**23507R4
July, 2024**

**SUBJECT: SAFETY RECALL
Grille surround on certain 2020 thru 2024
International® HX® Series trucks built 03/13/2019
thru 02/28/2023**

Parts Information and Service Procedure have been updated to begin replacing grille surrounds on HX520 Series trucks.

Figure 1. HX615 and HX620 Models Grille Surround Removal

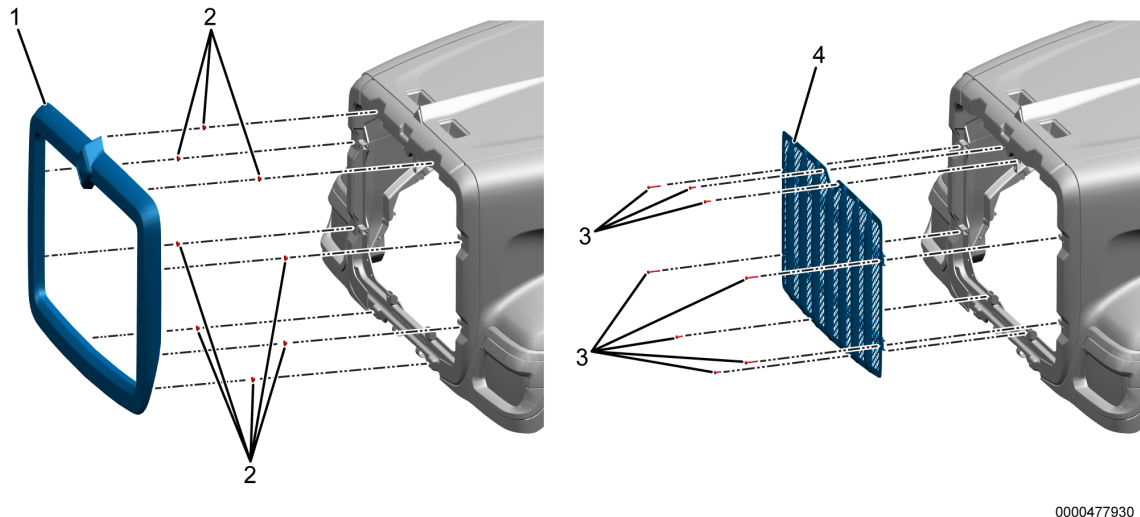
1. M8 palnut (2)
 2. Grille assembly
 3. M8 Keps nut (8)
 4. Grille surround
2. Remove eight M8 Keps nuts (Figure 1, Item 3) from the back of grille surround (Figure 1, Item 4). Save M8 Keps nuts for reuse.
 3. Remove grille assembly (Figure 1, Item 2) from truck by pushing inward and rotating 90 degrees to remove it through hood opening.
 4. Remove two M8 palnuts (Figure 1, Item 1) from stud by rotating them counterclockwise. Save M8 palnuts for reuse.
 5. Remove and discard grille surround (Figure 1, Item 4).
 6. With hood in open position, position new grille surround (Figure 1, Item 4) into place on hood and install two M8 palnuts (Figure 1, Item 1).
 7. Install grille assembly (Figure 1, Item 2) inserting it through hood front opening, rotate grille 90 degrees, and position into place.

8. Install eight M8 Keps nuts (Figure 1, Item 3) and tighten nuts to 5.3–6.6 lb-ft (7.2–9.0 N·m).
9. Close and latch hood.
10. Remove wheel chocks.
